City of Aurora Building Division
Project: TMCA Cath Lab Laser
Address: 1501 S Potomac St.
Occupancy Group: IBC I-2
Construction Type: IBC IA-SPK
RSN: 1235013
Permit: 17-1351383

City of Aurora Building Division
Reviewed for Code Compliance
Approved as Noted: Erick B.
Date: Sep 01, 2017
2015 INTERNATIONAL CODES & 2017 NEC

SHEET TITLE:
ELECTRICAL LEGENDS, GENERAL NOTES, AND ABBREVIATIONS

SHEET TITLE:
E.301

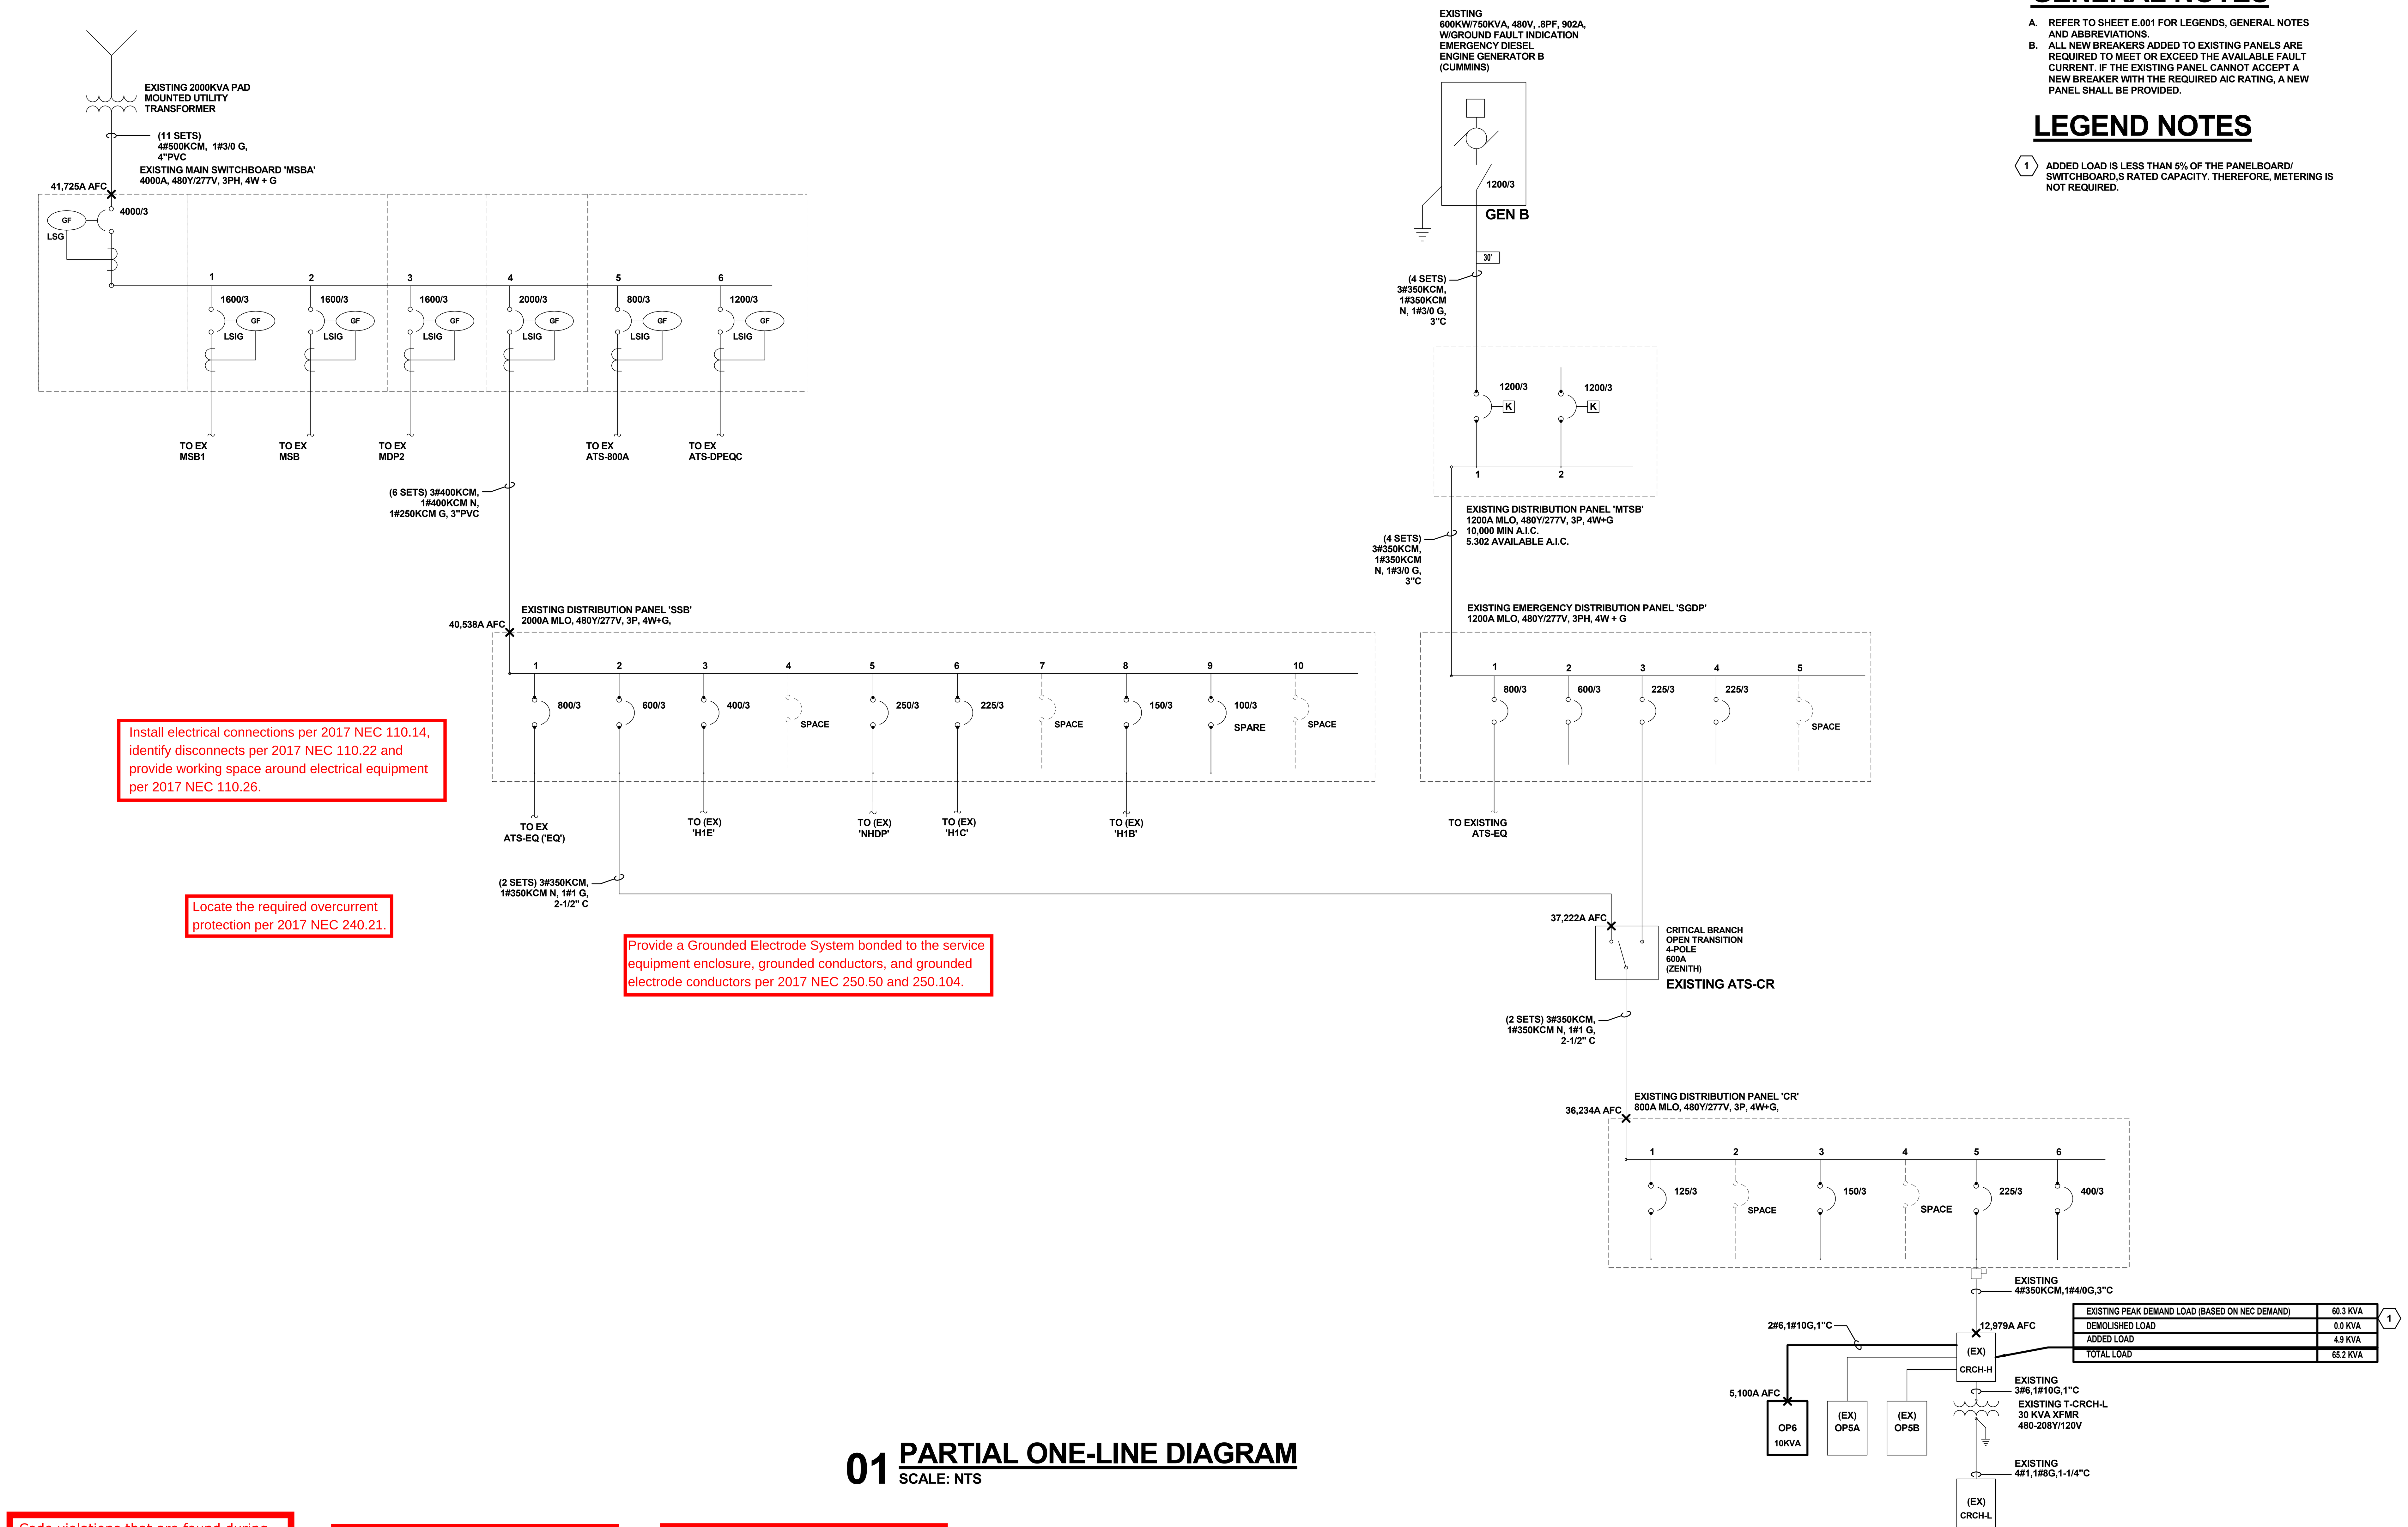
Service Equipment shall be permanently and legibly marked to show the available fault current and date the calculation was performed. 2017 NEC 110.24(A)(B).

Install electrical connections per 2017 NEC 110.14, identify disconnects per 2017 NEC 110.22 and provide working space around electrical equipment per 2017 NEC 110.26.

Locate the required overcurrent protection per 2017 NEC 240.21.

Provide a Grounded Electrode System bonded to the service equipment enclosure, grounded conductors, and grounded electrode conductors per 2017 NEC 250.50 and 250.104.

Every circuit and circuit modification shall be legibly identified as to it's clear, evident and specific purpose or use. The identification shall include an approved degree of detail that allows each circuit to be distinguished from all others. 2017 NEC 408.4
